SERVICE BULLETIN #56

SUBJECT: Stop for Cabin Door Air Vent

ROTORCRAFT AFFECTED: R22 Series Helicopters, Serial No's 002-622

FIGURE 1

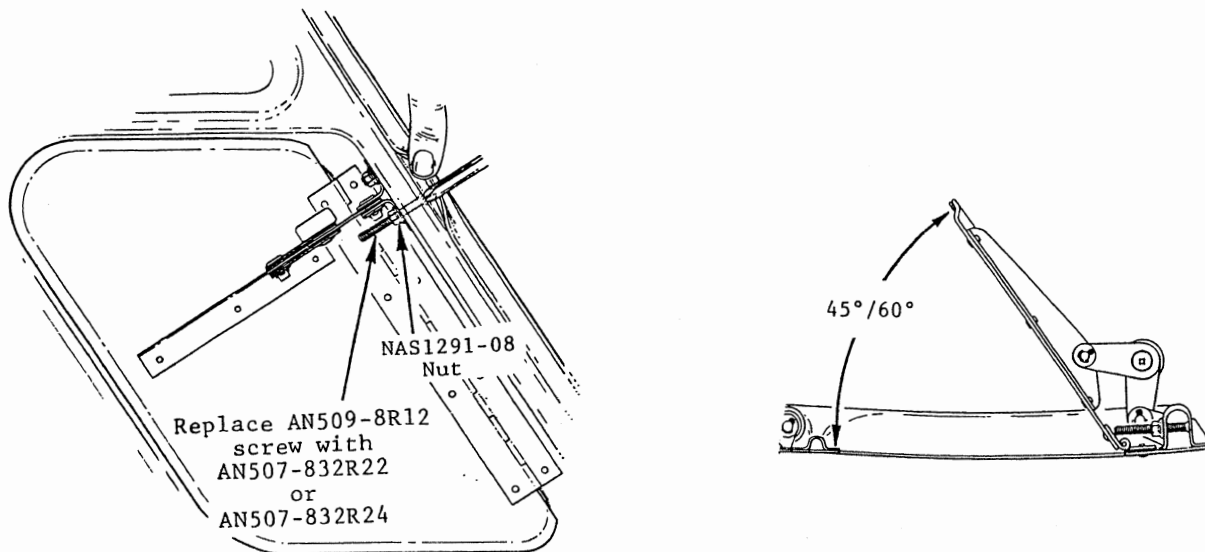
1. Obtain KI-54 Kit from RHC Customer Service Department (n/c).
2. Peel back weatherstripping from the edge of the cabin door in the area of the vent linkage and remove the lower AN509-8R12 screw (see Figure 1).
3. Insert one of the longer AN507-832R24 screws provided and hold in place with finger pressure. Check the vent opening angle, it should be between 45° and 60°. If the angle is too small, try the shorter AN507-832R22 screw (see Figure 1).
4. After selecting the correct length screw, reinstall the NAS1291-08 nut and secure weatherstripping with a locally procured contact cement suitable for rubber.
5. Repeat steps 1 thru 3 for second door and enter Service Bulletin #56 in log book.
